The Northern Road Upgrade

Glenmore Parkway, Glenmore Park to Jamison Road, South Penrith

Submissions Report

January 2017

Figure 4-1: Right turn entry lane for properties on western side of The Northern Road

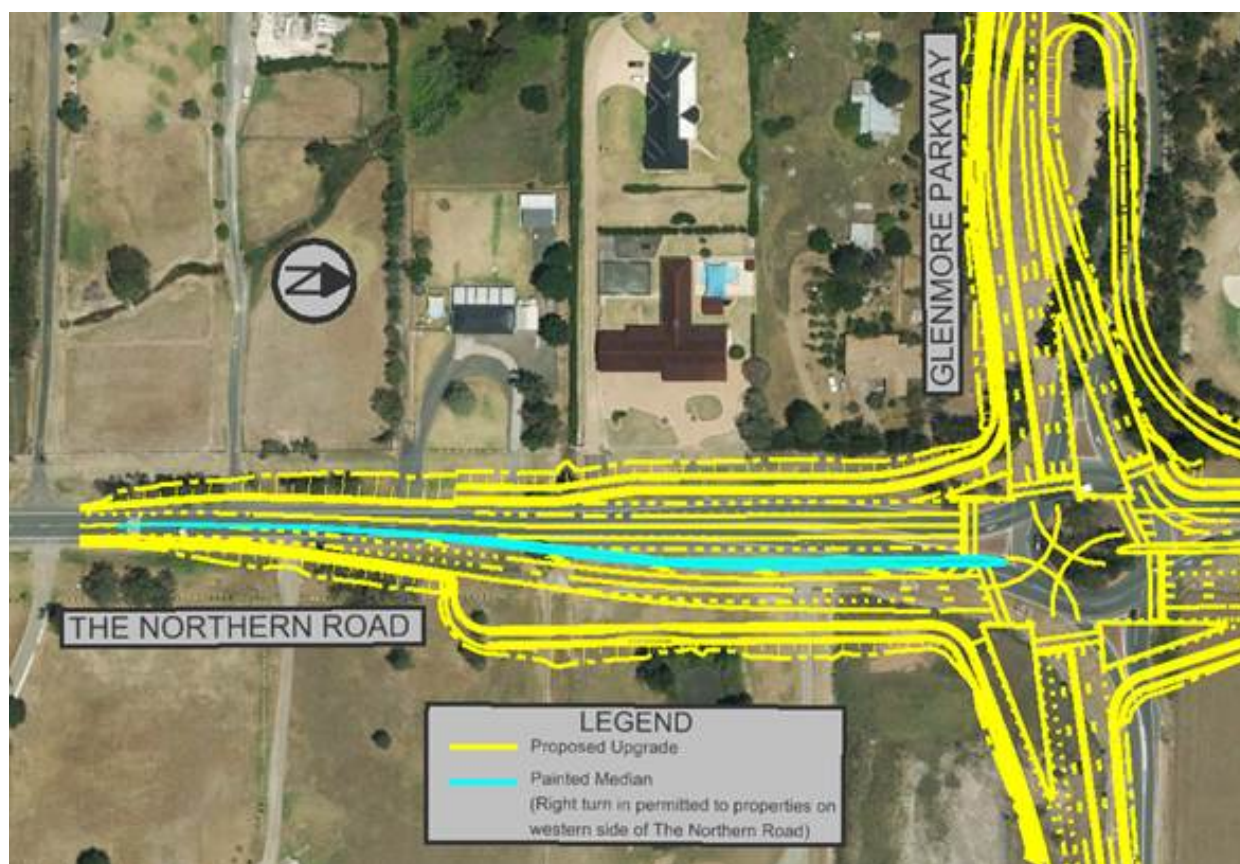
In response to feedback received about access to properties south of Glenmore Parkway. The proposed upgrade would be amended to include a southbound right turn entry lane within the central median of The Northern Road to provide access to several properties on the western side of the road corridor. Right turn out access would also be permitted for the three properties on the eastern side of The Northern Road.

The proposed change would provide safe and reasonable form of access until further stages of The Northern Road are constructed to the south including a facility for U-turn movements near Bradley Street. Upon completion of a U-turn facility this proposed median turning lane would be removed and replaced with a central median between Glenmore Parkway and Bradley Street as part of further upgrades along The Northern Road.

Right turn entry movements would not be permitted to properties on the eastern side of The Northern Road and right turn out movement would not be permitted across the median for properties on the western side of The Northern Road. These movements would be catered for by the proposed roundabout in Glenmore Parkway which is assessed in Section 6.1 of the REF.

The proposed change includes a right turn entry lane south of Glenmore Parkway to provide access to about four driveways on the western side of The Northern Road. The right turn entry lane would separate right turn entry traffic from through traffic along The Northern Road. This would substantially reduce the risk of rear end crashes.

Figure 4-2: Additional retaining wall near Penrith Christian School playing field

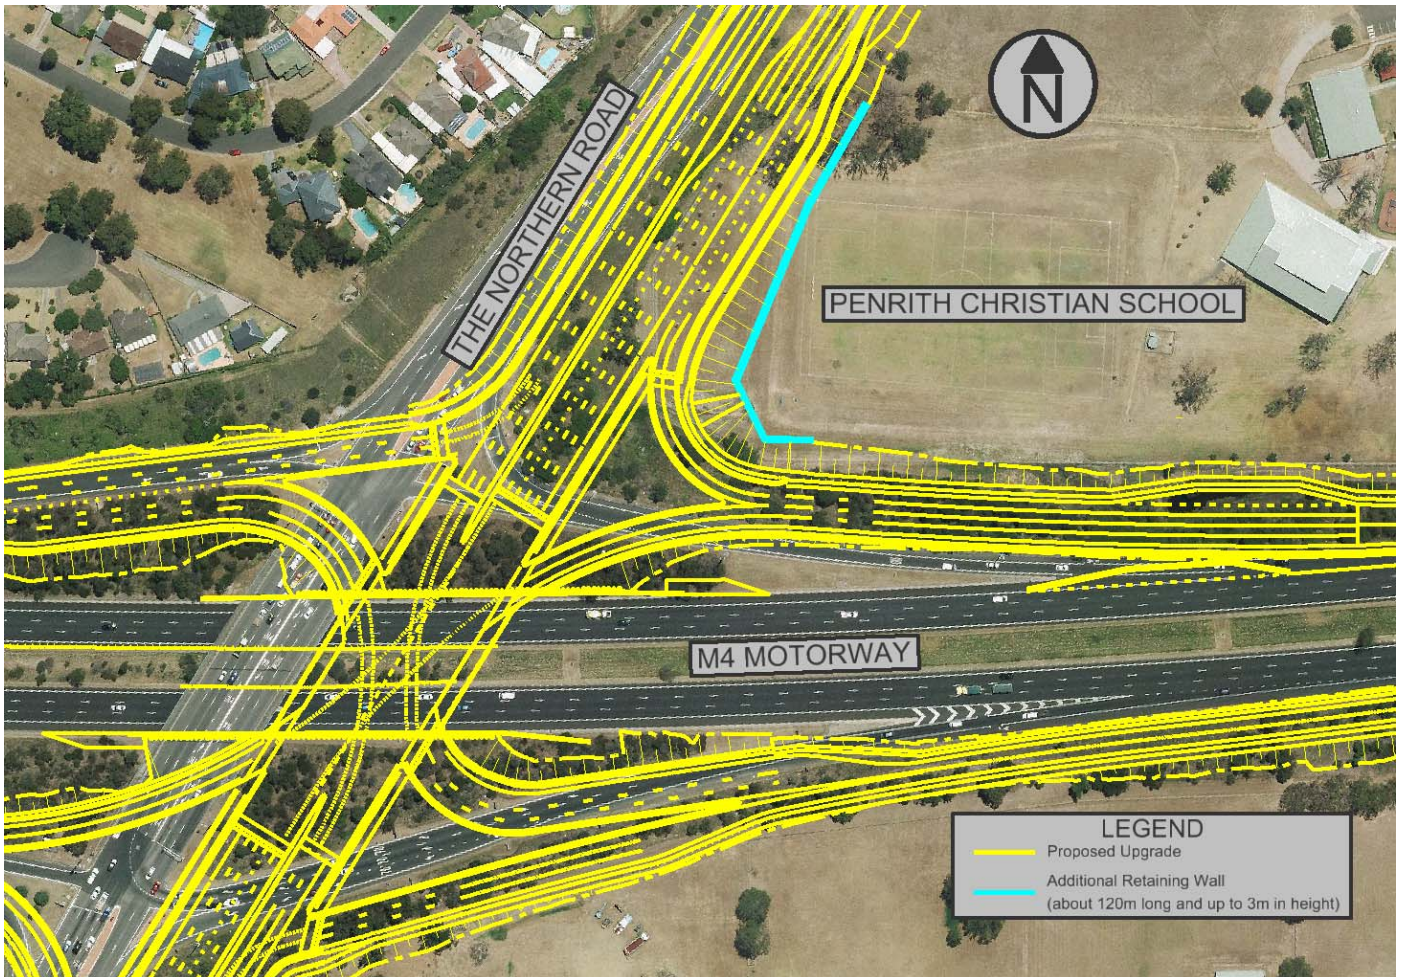
Following a change to the slope of the batter on the eastern side of The Northern Road to suit soil conditions, the proposed upgrade would be amended to include a retaining wall near the Penrith Christian School playing field. The retaining wall would be located along the bottom of the embankment to limit the width of the embankment and impact on Penrith Christian School. The proposed land acquisition would remain as identified in Section 3.6 of the REF.

The proposed change includes a retaining wall at the bottom of the fill embankment which is required to widen The Northern Road to the east. The retaining wall would start at the corner of the M4 Motorway eastbound entry ramp and continues north for about 120 metres. It would be up to three metres in height.

The proposed change maintains the existing land acquisition identified in Section 3.6 of the REF and avoids further impacts to property adjustments on the school grounds. The retaining wall would allow disruption of the school's operation to be minimised by reducing the size of the batter. This avoids any further socio-economic impacts to the school during construction of the proposed upgrade.

Figure 4-3: Proposed parking changes (Source: Google Maps,)

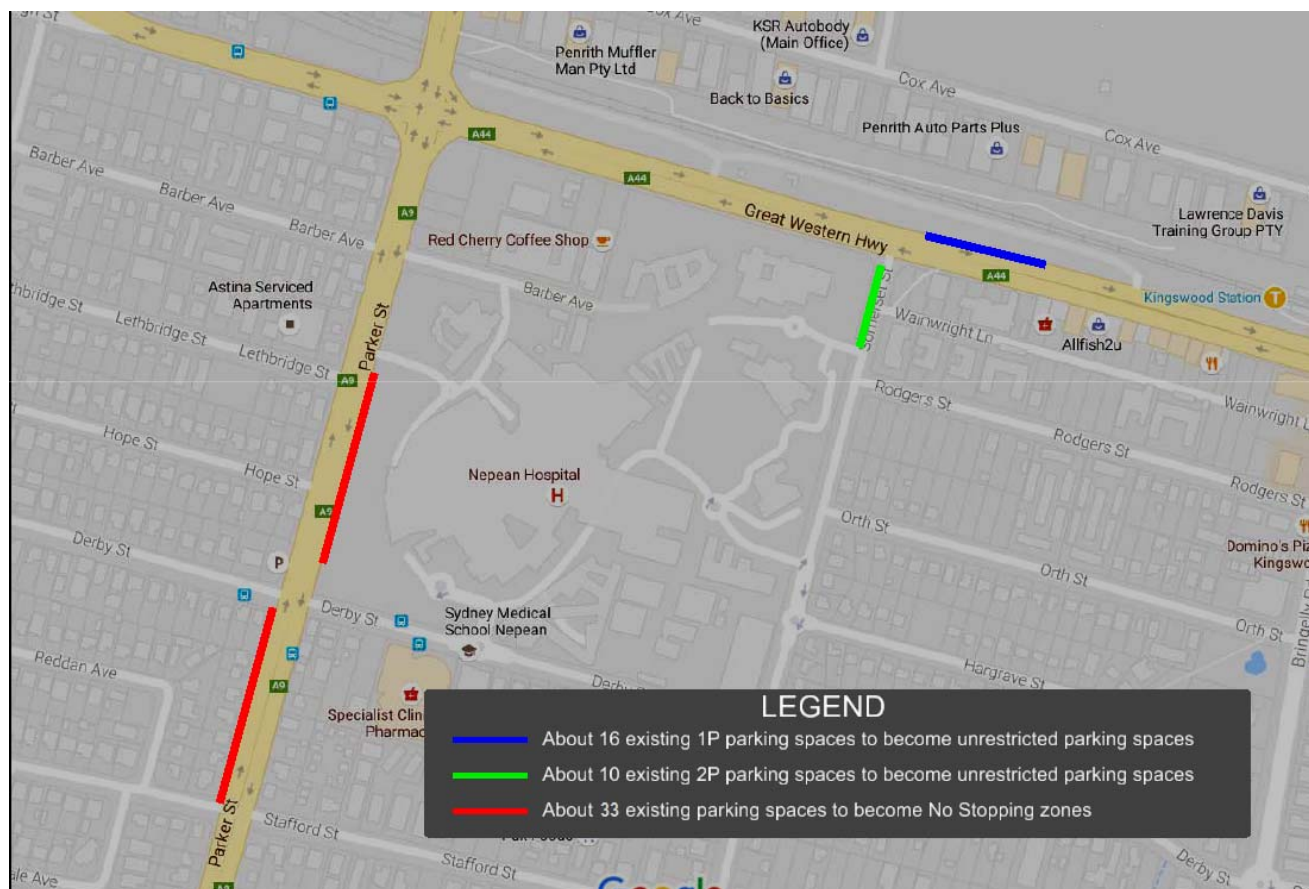
In response to feedback received requesting the removal of all kerbside parking between Stafford Street and the Great Western Highway. The proposed upgrade now includes removing parking on The Northern Road from Stafford Street to Derby Street which accounts for about 9 parking spaces and from the Great Western Highway to Derby Street which accounts for about 24 parking spaces. This would result in the loss of about 33 unrestricted parking spaces in total.

The parking between Stafford Street and Derby Street is utilised and is adjacent to residential properties which have sufficient front yard vehicle storage. The parking is currently unrestricted and utilised for long durations, often exceeding four hours, which suggests it is utilised by visitors to Nepean Hospital instead of the adjacent residences. Removal of this parking would provide three clear traffic lanes between Jamison Road and Derby Street in both directions and improve road safety.

The removal of parking between the Great Western Highway and Derby Street is limited to the southbound carriageway and would affect about 24 existing parking spaces. The parking spaces are heavily utilised and the average duration exceeds six hours. This parking is utilised by visitors to the adjacent Nepean Hospital. Given the difficulties in parking at Nepean Hospital until further redevelopment of the site is completed alternative parking opportunities would be made available within Somerset Street and the Great Western Highway to offset the removed parking spaces on The Northern Road.

The proposed change includes removing about 9 parking spaces between Stafford Street and Derby Street without compensatory parking. This parking is currently utilised although results in a number of key issues listed below:

The residences between Stafford Street and Derby Street have sufficient setbacks and space within their front yard to accommodate parking. The removal of parking would offer significant improvements to road safety and congestion relief without impacting the residences which do not appear to heavily rely upon the parking and can park within their front yards. For these reasons, it is proposed to remove about 9 parking spaces along The Northern Road between Stafford Street and Derby Street as part of this proposal.

- Removal of a section of 2 hour parking along the Great Western Highway eastbound to provide an additional 16 unrestricted parking spaces
- Removal of a section of 1 hour parking along Somerset Street northbound to provide an additional 10 unrestricted parking spaces
